Errata Sheet

SMUD Trail Project

**Project Initial Study/Mitigated Negative
Declaration**

ERRATA SHEET FOR THE SMUD TRAIL PROJECT INITIAL STUDY/MITIGATED NEGATIVE DECLARATION

FIGURE 4

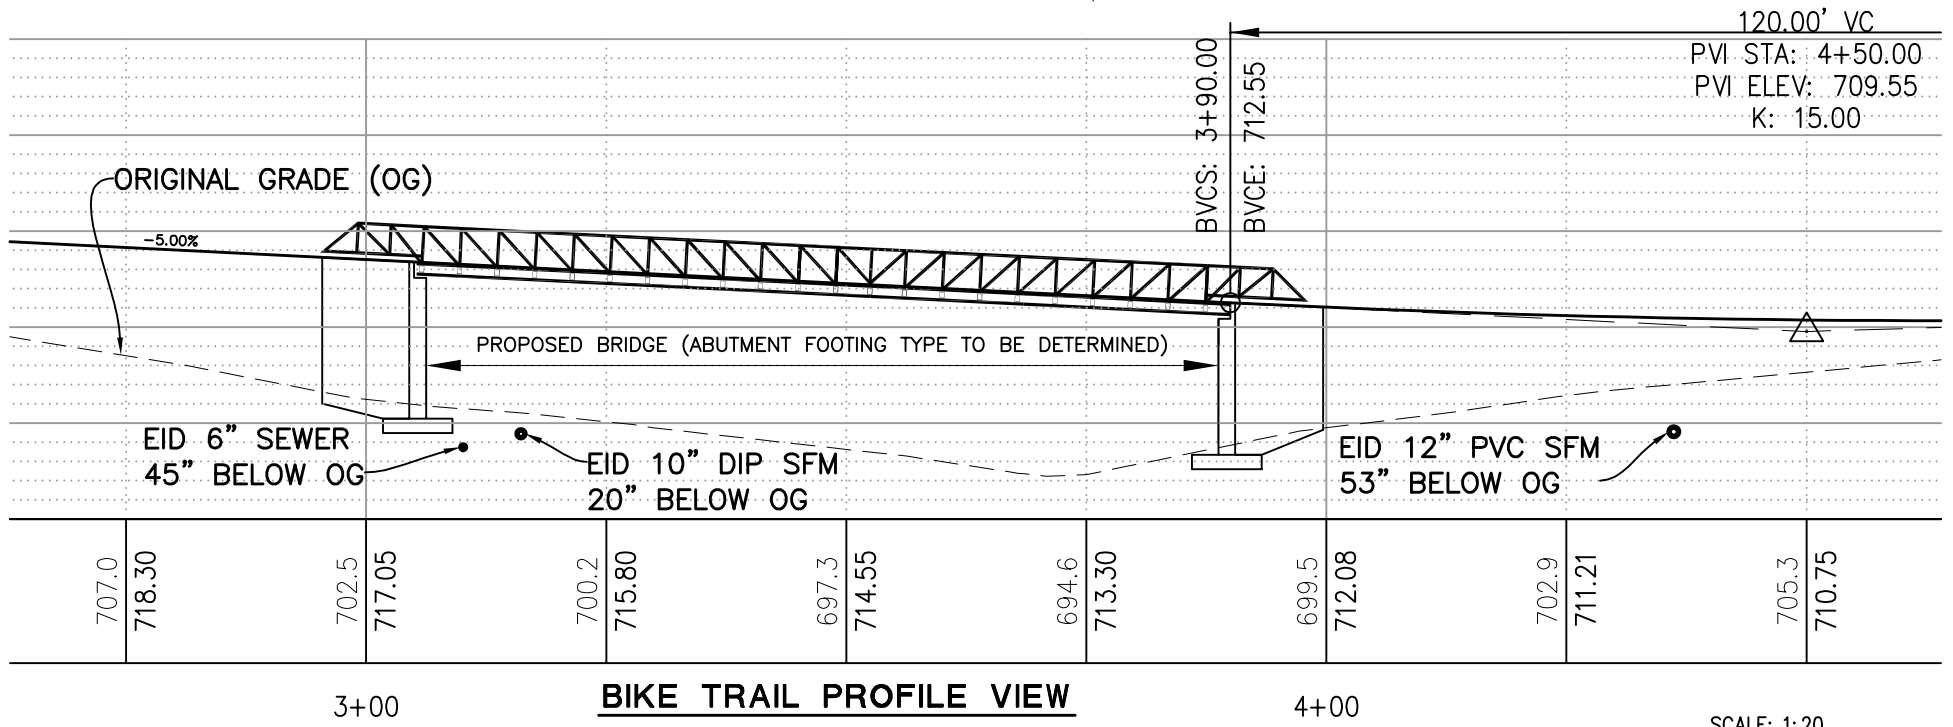
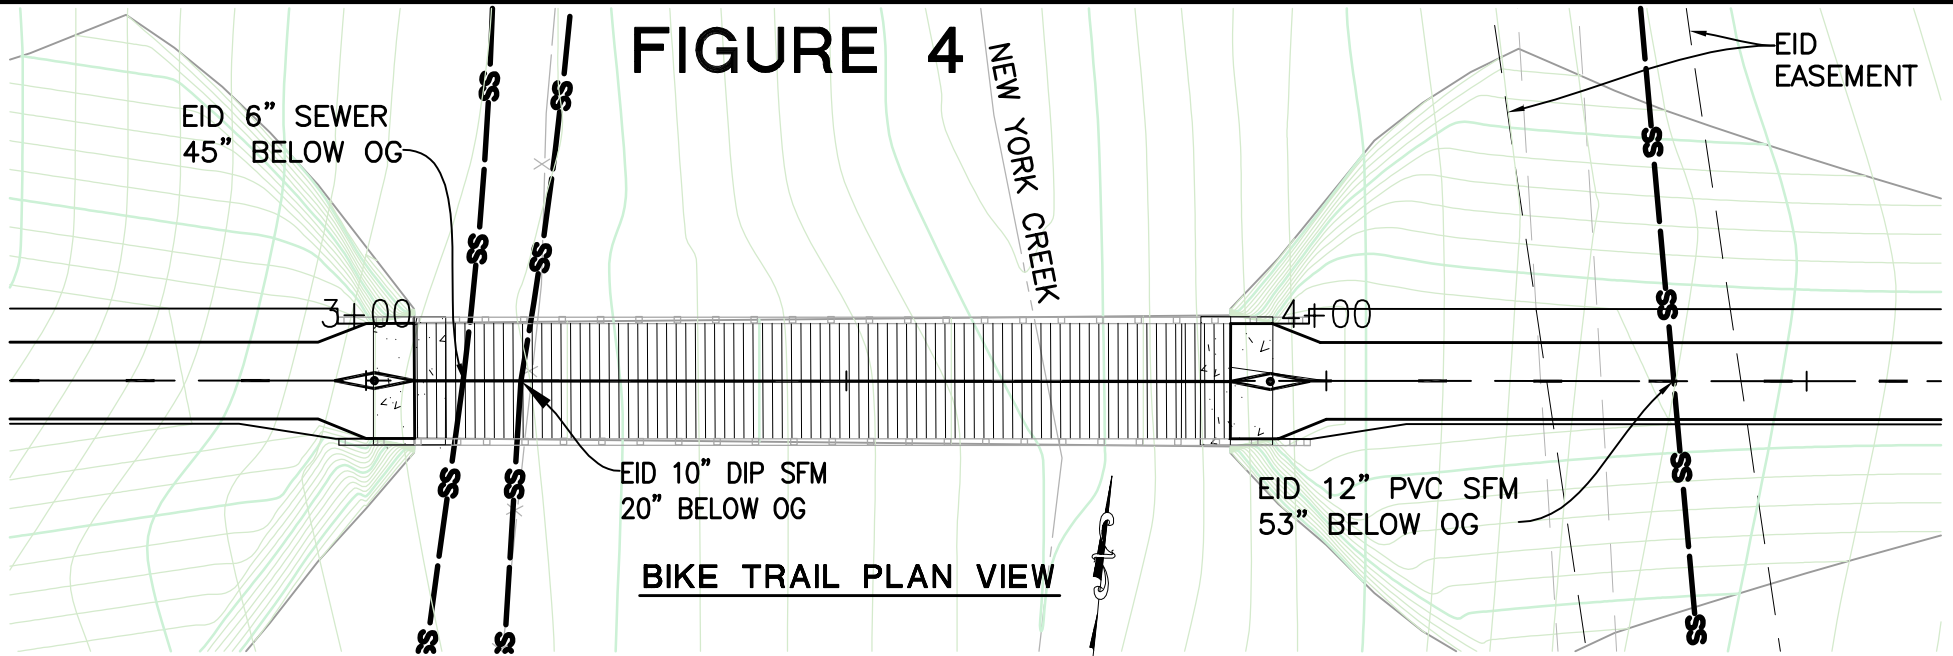
There are 3 existing underground sewer lines and associated appurtenances running north-south along the east and west banks of New York Creek in the Project APE. The proposed trail would cross these facilities but would not impact them. On the west side of New York Creek (toward Tam O'Shanter), both a gravity and sewer force main (SFM) are located under the free span of the proposed bridge. A 6-inch sewer line that is 45-inches below existing grade is 5-feet from the face of the proposed abutment. A 10-inch ductile iron pipe (DIP) SFM, that is only 20-inches below the existing grade, is 11-feet from the face of the proposed abutment (See Figure 4).

On the east side of New York Creek (toward Silva Valley Parkway), a 12-inch PVC sewer force main line is 53-inches below the existing grade, and located 36-feet east of the easterly proposed abutment under 6 to 7 feet of proposed fill approaching the bridge. Additionally, an air relief valve is located within the study area, but approximately 100 feet south of the proposed bike trail on the east side of New York Creek. DOT staff has designed the Project to avoid any impacts upon the EID facilities. DOT will continue to consult with EID staff throughout design and construction to avoid any conflicts with EID facilities.

There are 3 EID underground sewer lines and associated appurtenances running north-south along the east and west banks of New York Creek in the Project area (Figure 4). The proposed trail would cross these facilities but would not impact them. On the west side of New York Creek (toward Tam O'Shanter), both a gravity and sewer force main (SFM) are located under the free span of the proposed bridge. A 6-inch sewer line that is 45-inches below existing grade is 5-feet from the face of the proposed abutment. A 10-inch ductile iron pipe (DIP) SFM, that is only 20-inches below the existing grade, is 11-feet from the face of the proposed abutment.

On the east side of New York Creek (toward Silva Valley Parkway), a 12-inch PVC sewer force main line is 53-inches below the existing grade, and located 36-feet east of the easterly proposed abutment under the 6 to 7 feet of proposed fill approaching the bridge. Additionally, an air relief valve is located within the study area, but approximately 100 feet south of the proposed bike trail on the east side of New York Creek. DOT staff has designed the Project to avoid any impacts upon the EID facilities. DOT will continue to consult with EID staff through out design and construction to avoid any conflicts with EID facilities.
